STAFF REPORT 06-22-2916 MEETING

APPLICATION NUMBER 16-4674

ADDRESS: 1566 BAGLEY

HISTORIC DISTRICT: CORKTOWN

Dates & Revisions
PERMIT SET 04.12.2016

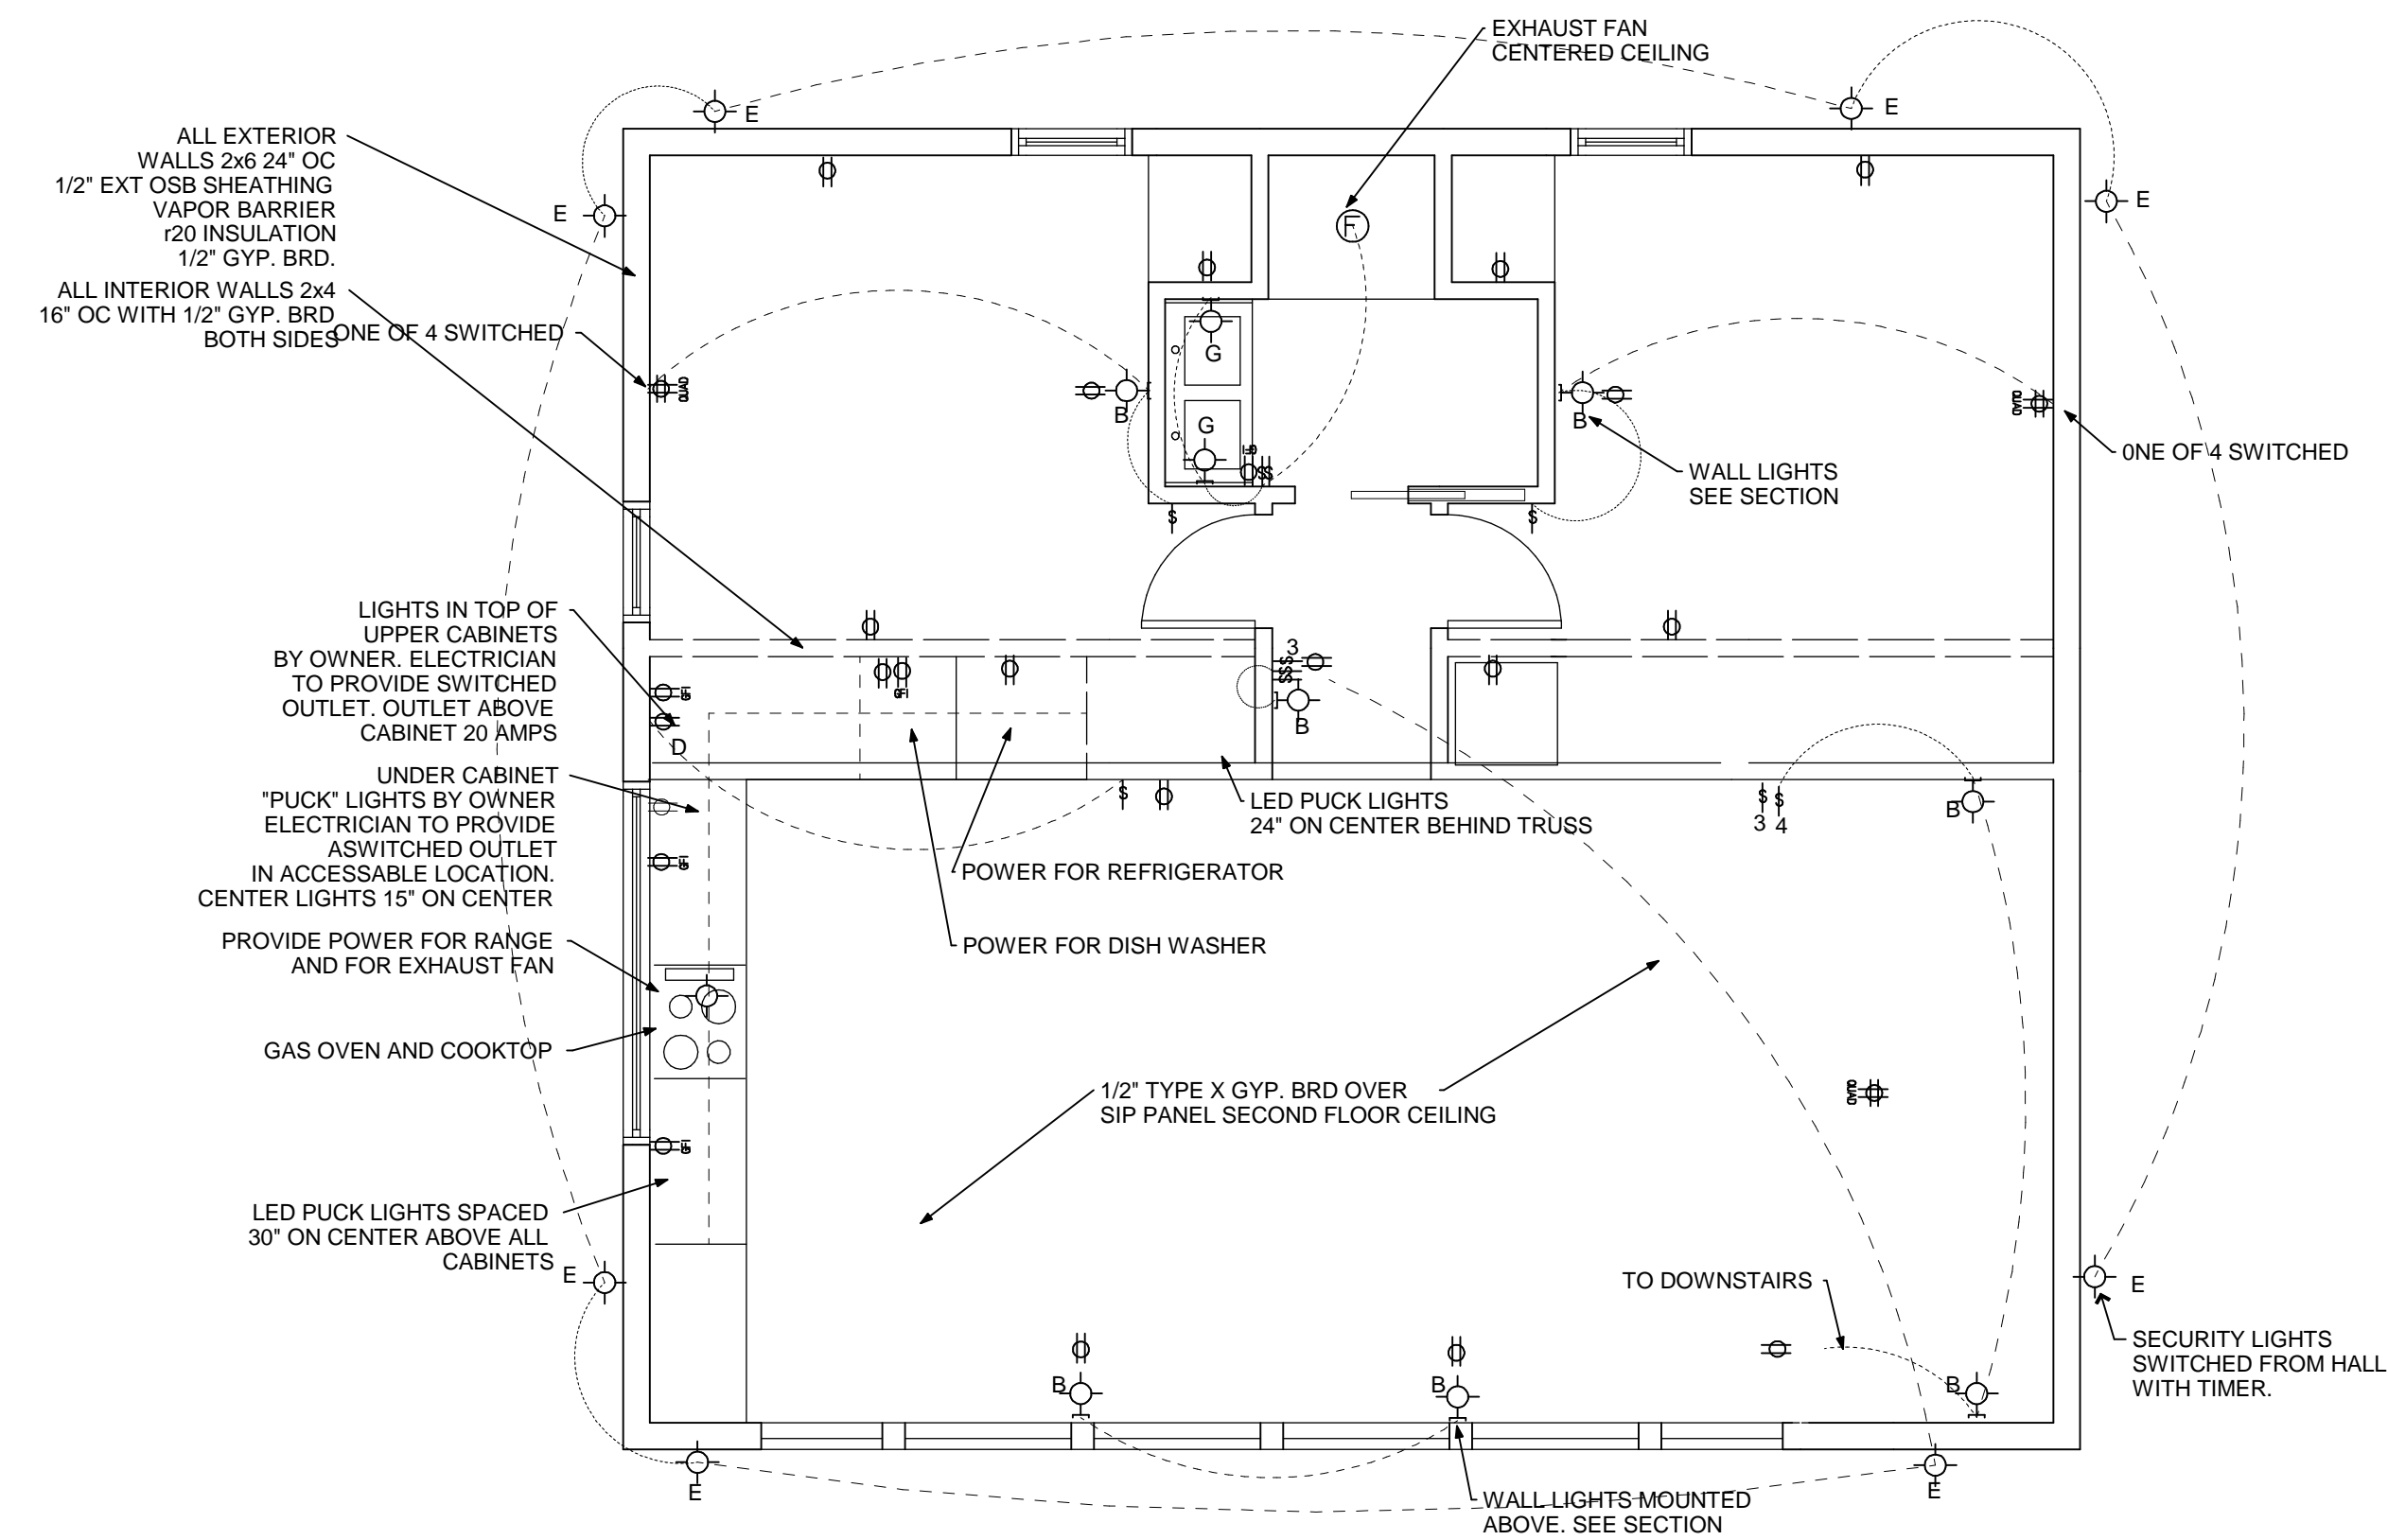
It is noted that the home's setback *is not* consistent with the existing architecture within the 1500 block of Bagley. Also, vertical metal siding is not commonly found at the exterior walls of residential properties within the district. Please see the following *Elements of Design* for the district which and note that the proposed design is generally not in keeping with the neighborhood's prevailing architectural character. However, please see the **submitted narrative** which outlines the applicant's purpose for locating the home to the rear of the lot and discusses their choice of material and the building design. Also, please see the **attached email** from the

- The house shall be clad with a wood siding or masonry so that the building’s appearance is more compatible to the existing historic architecture within the neighborhood. Staff shall be afforded the opportunity to review and approve the siding material and finish color before the COA is issued and the permit is pulled for the work. If staff feels that the selected material does not conform to the district’s Elements of Design, staff shall forward the work item to the Commission for a review at a meeting.

The metal siding was chosen for its durability, modern character but also it's abstract connection to historical board and batten siding. Admittedly there are few examples of vertical board and batten in Corktown and so there is not a direct connection to the context. There is a textural connection that is it is a linear siding that has a board like quality. The Architect and Owner believe this allows the house to relate to but not copy the siding of the older homes. But would to switch to a horizontal metal siding closer to clapboard if the committee so desires.
